SLO.DOA.002	<h2>Service Information</h2>	Document Number
		SI-100-005
		Issue: A.01
Pipistrel d.o.o. Ajdovščina Goriška cesta 50a SI-5270 Ajdovščina, Slovenia www.pipistrel.eu Phone: +38653663873	Introduction of a new maintenance task (inspection of elevator bell-crank attachment bolts)	Supersedes Doc. Number
		N/A
		Page 1 of 3
Aircraft make	Aircraft model	Affected serial numbers
PIPISTREL	Sinus, Virus, Virus SW, Alpha Trainer	See cover page
Date of release	Date of effect	Date of required corrective action
26 January 2016	26 January 2016	At next 100 hr service interval

Introduction of a new maintenance task

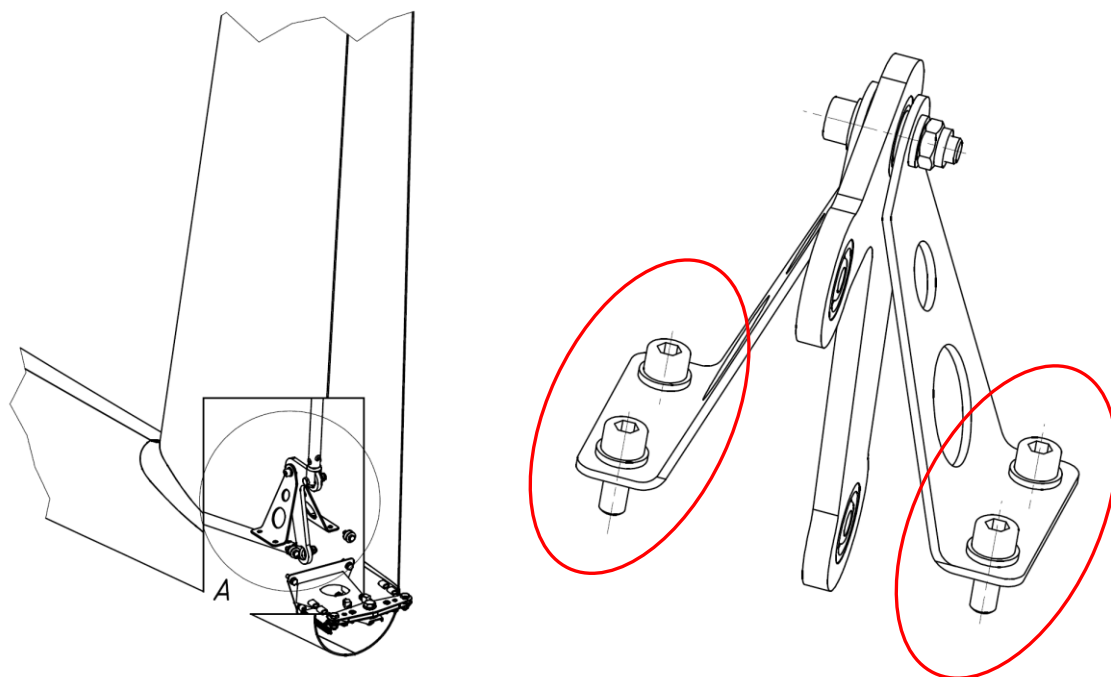
It was noticed in the field that certain older aircraft exposed to a saline environment and/or those predominantly parked outside started showing evidence of surface corrosion on the bell-crank attachment bolts. An inspection is therefore put in place as part of the 500 hr inspection.

At next 100 hr service interval Inspect elevator bell-crank attachment bolts for corrosion and replace on condition with PN 5010655. To access the bell-crank it is necessary to remove the rudder. Make sure the rudder is reintroduced and secured properly after the inspection.

Thereafter, carry out inspection every 500 hrs.
